### ADDENDUM #3

**PROJECT:** Farmington City  
Ivy Acres Park  
New Park Project

**DATE:** June 14, 2024

**ENGINEER:** Blu Line Designs

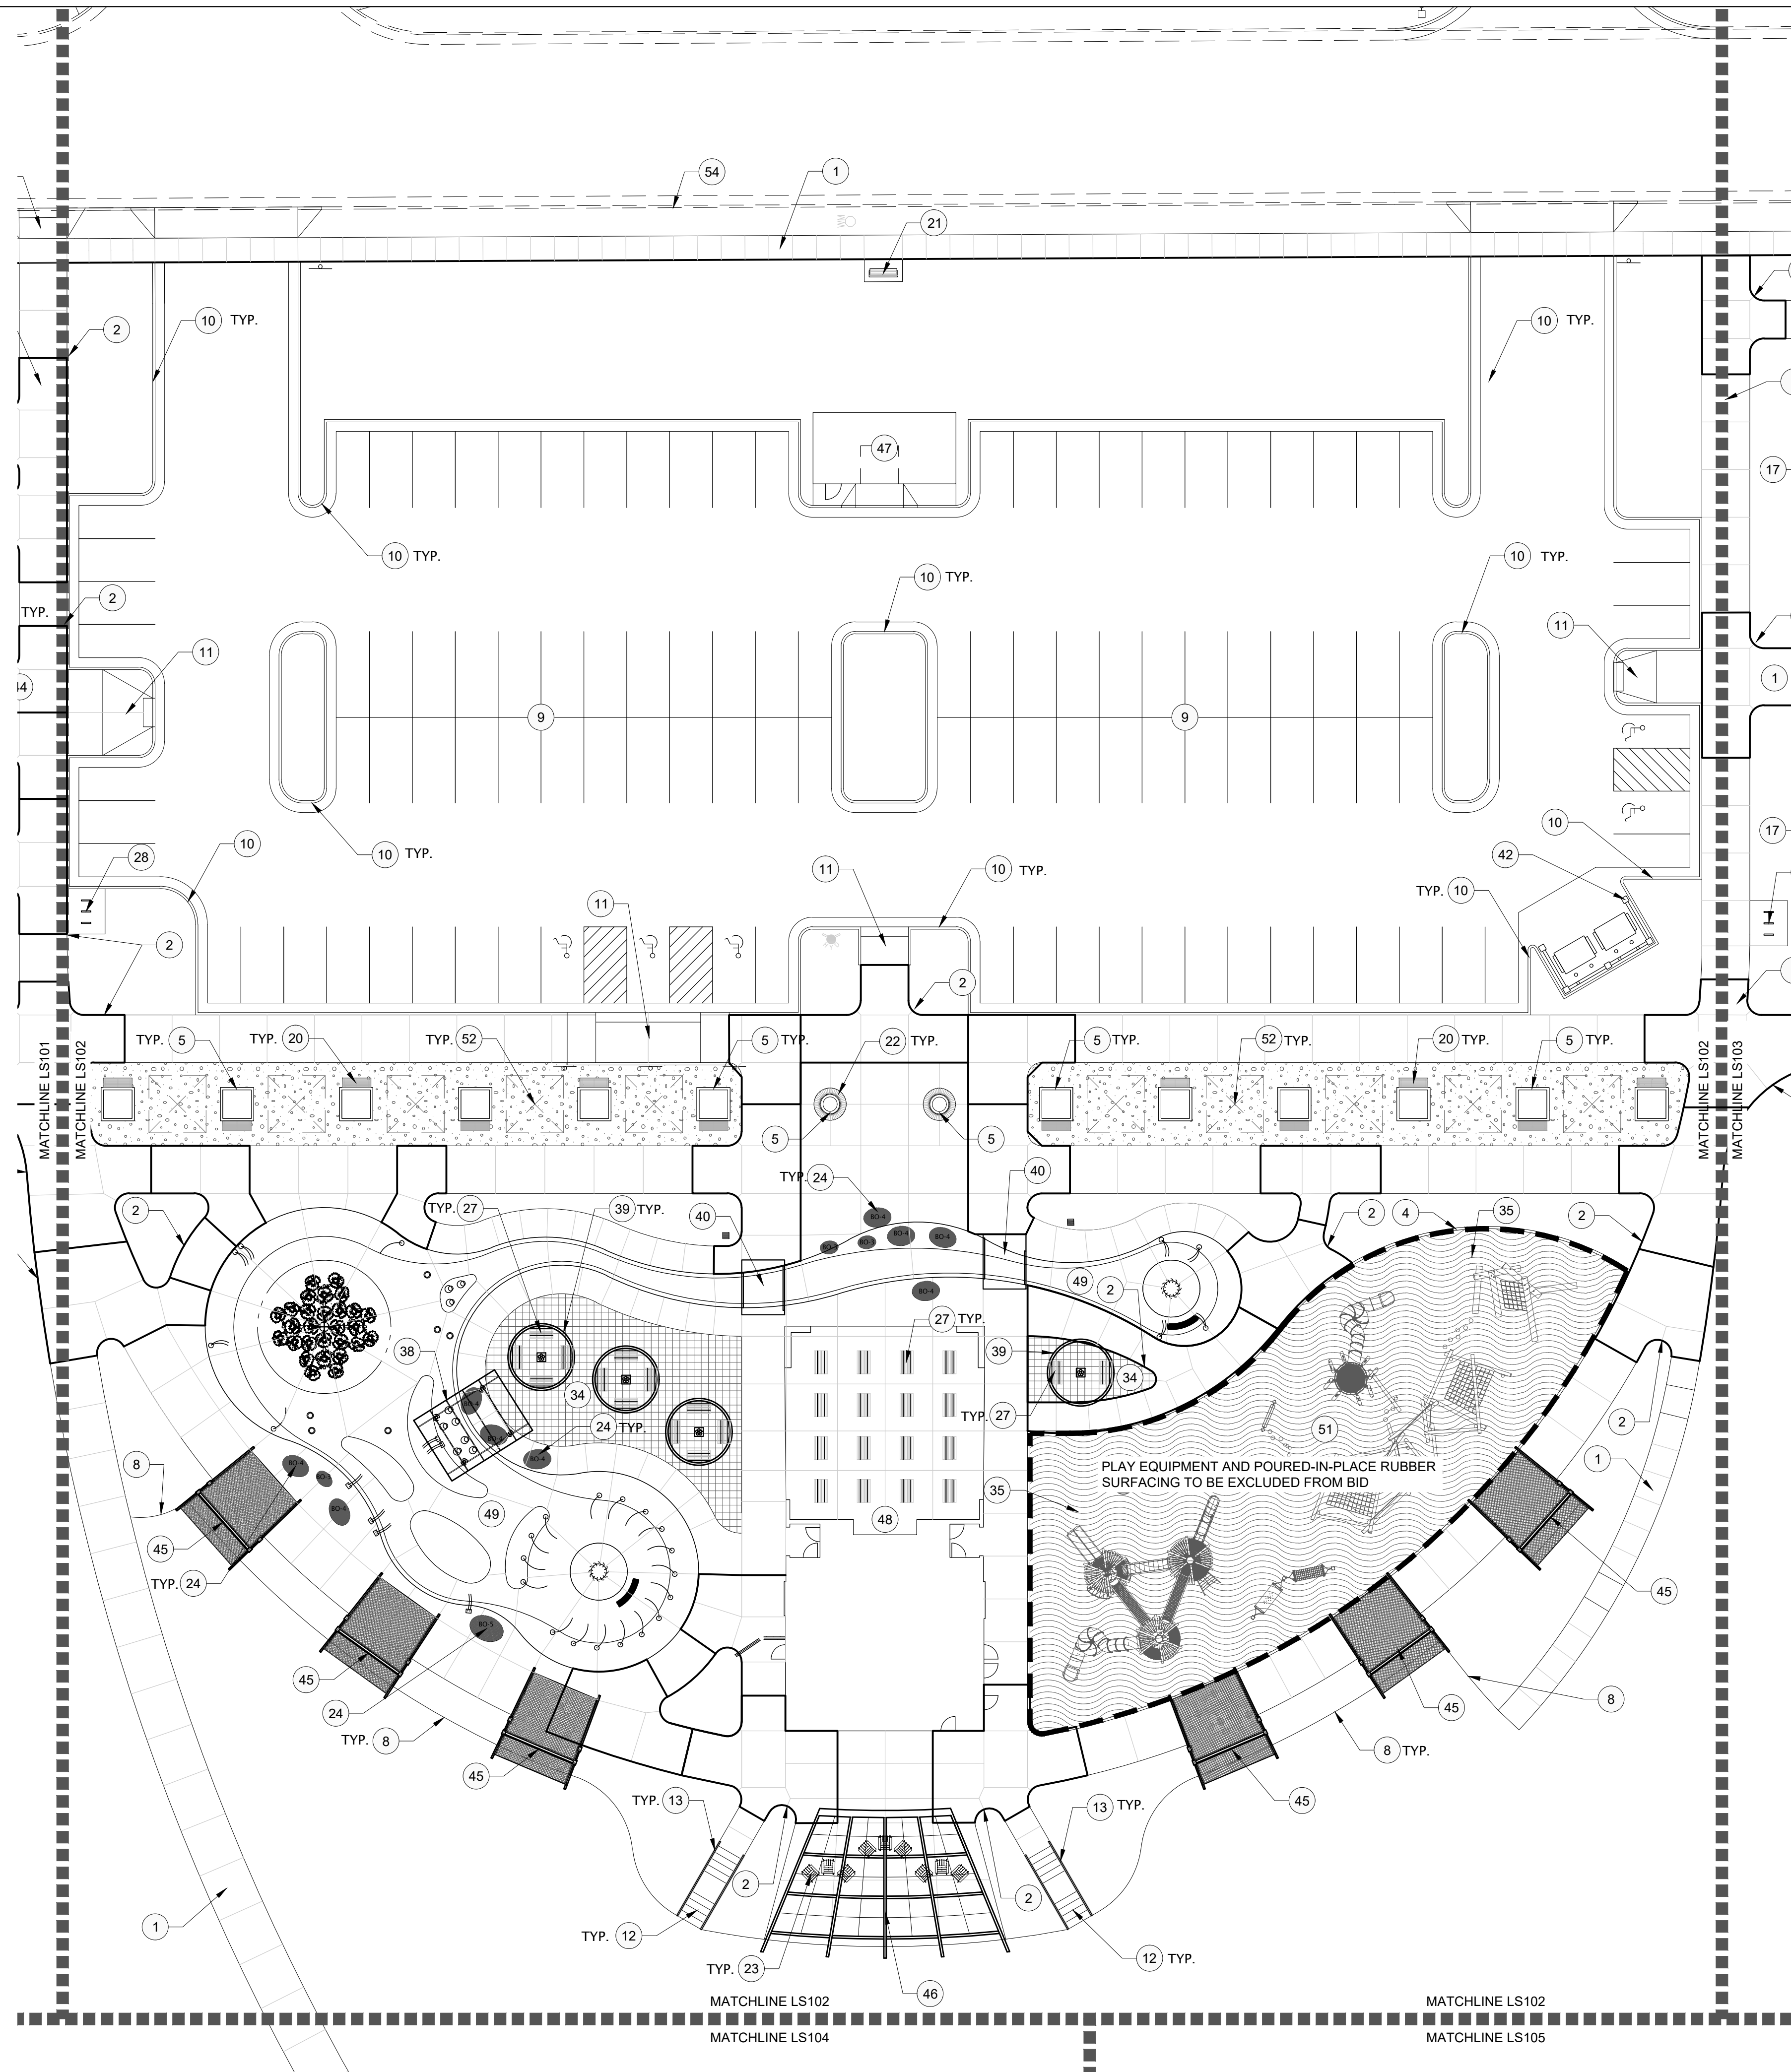
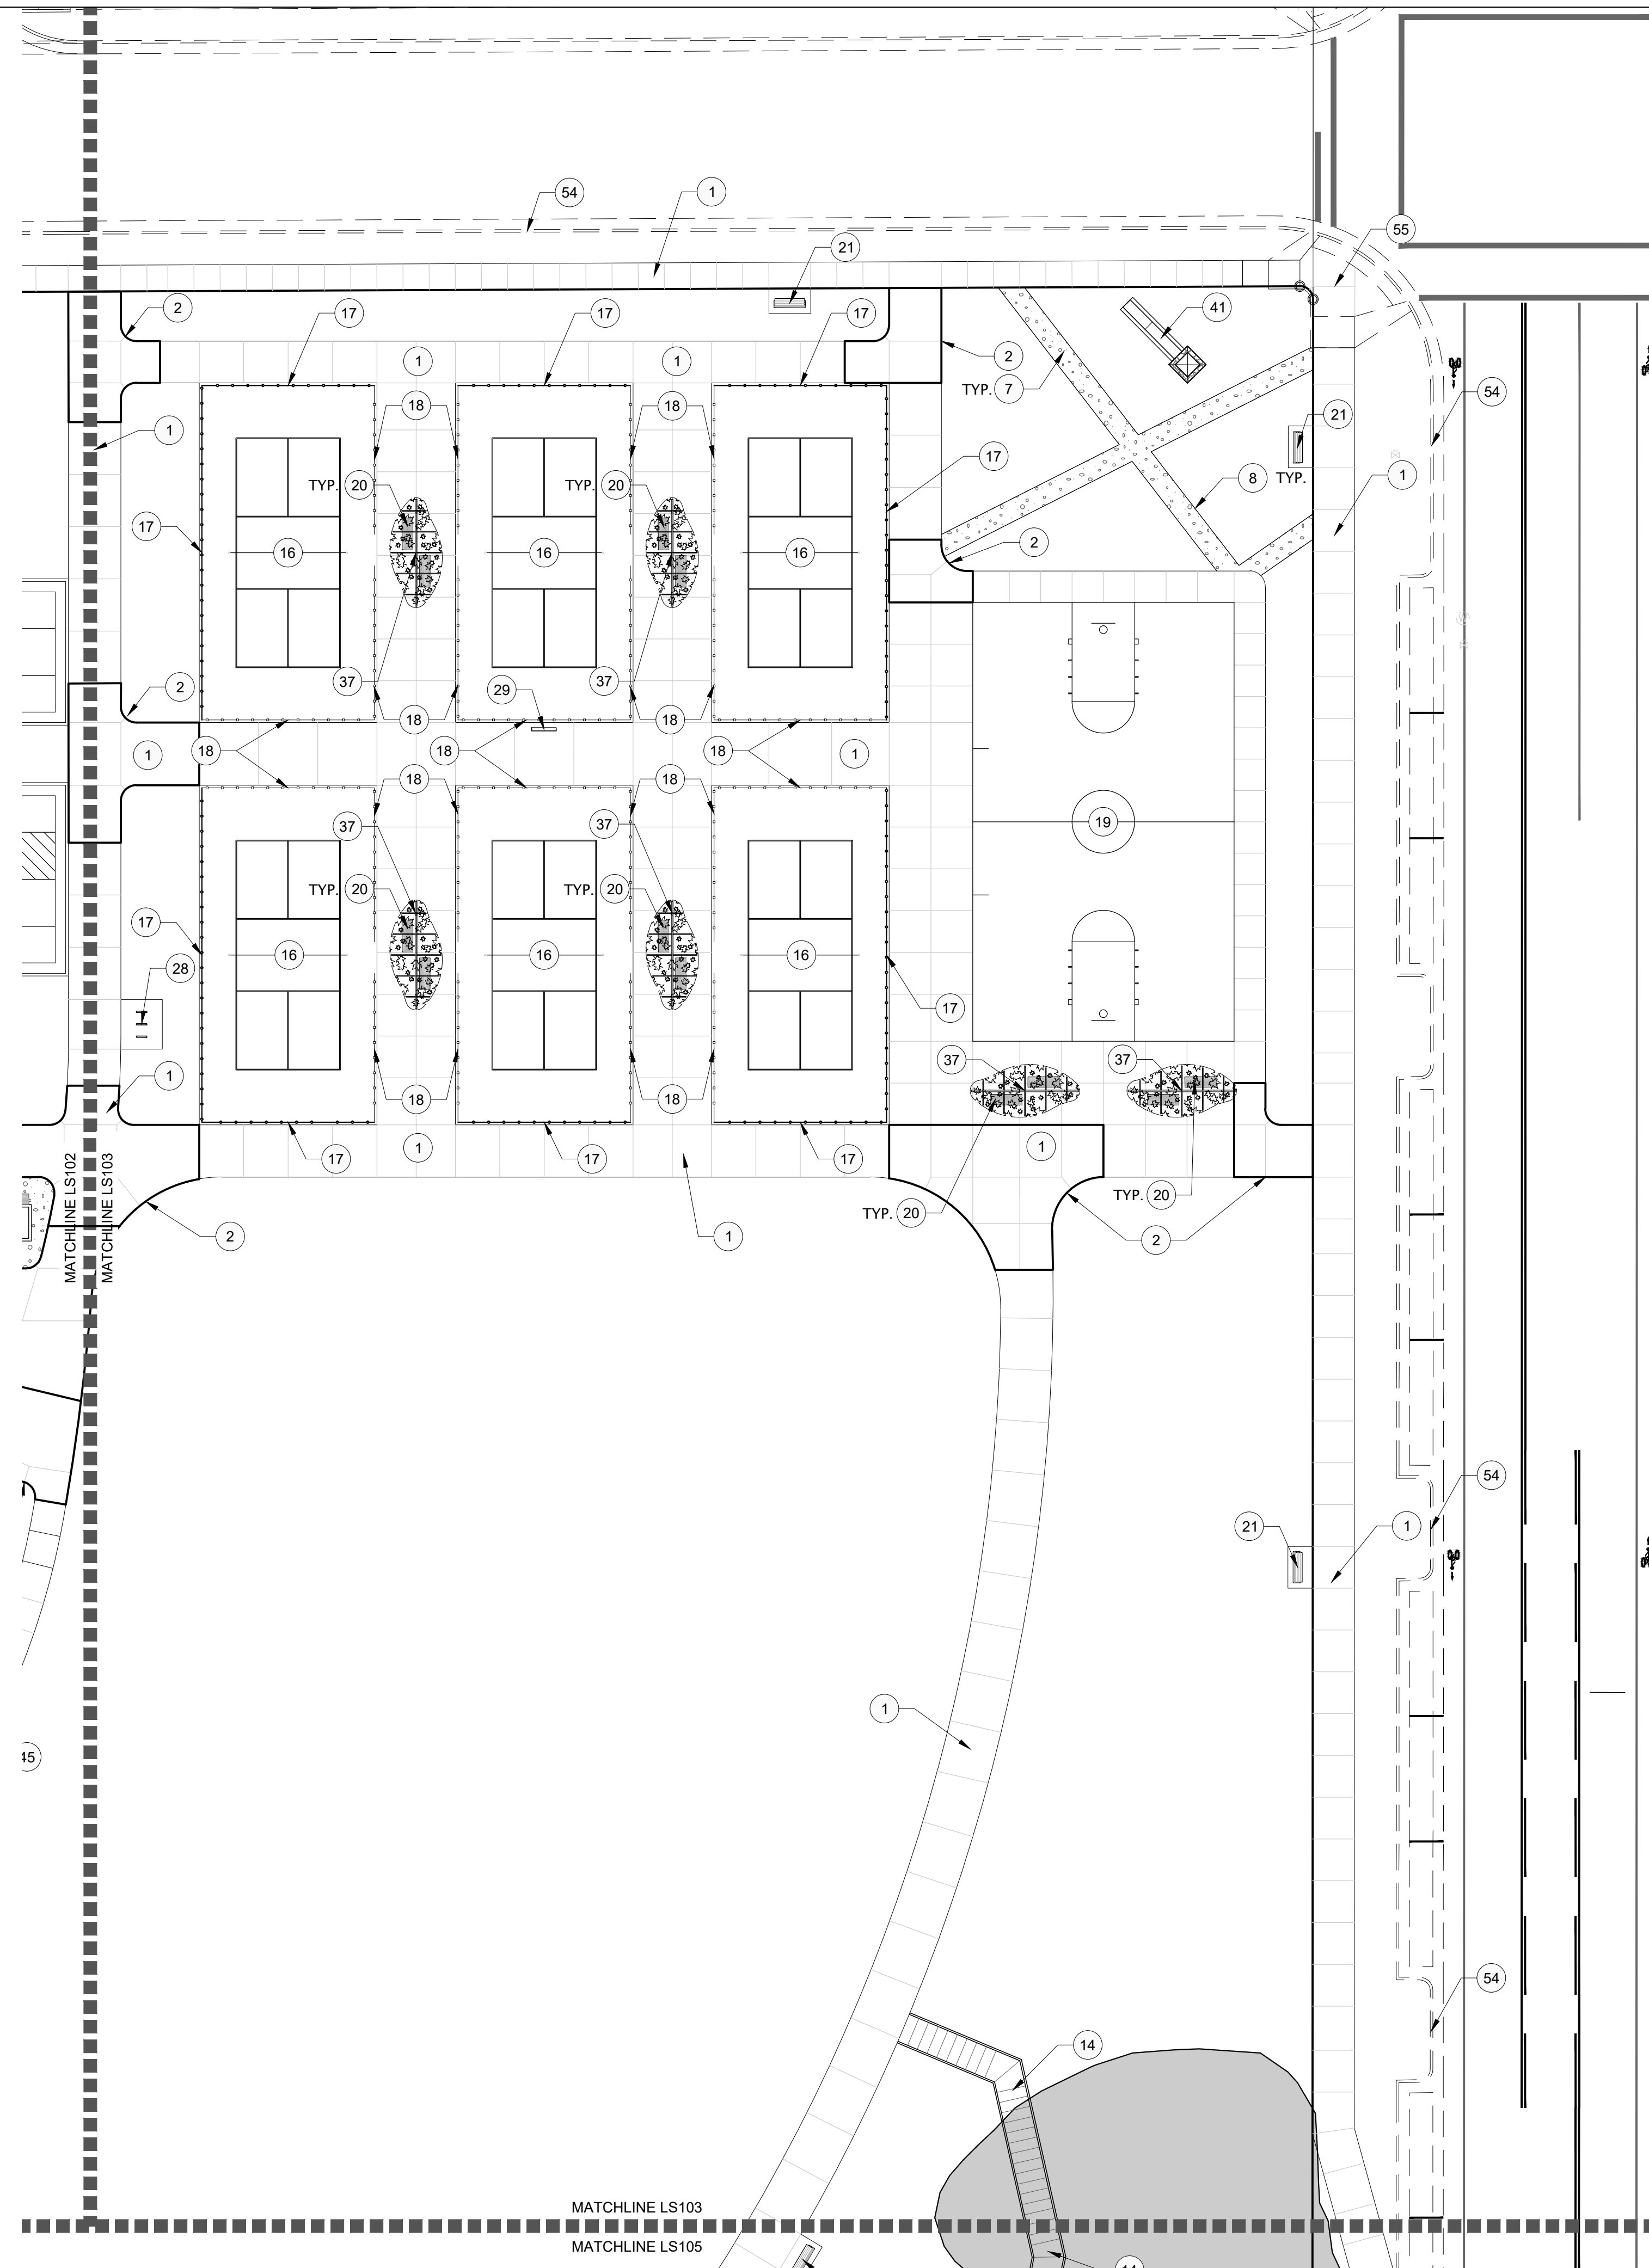
Item 3.1 **LS-101 thru LS-105:** Reference note schedule detail call outs are incorrect. Call outs and page numbers appear to be off. Please Review, revise and advise.

- Details that were being referenced to page LS-103 have now been corrected and will be shown correctly in sheets LS101-105 Schedule. See attached.
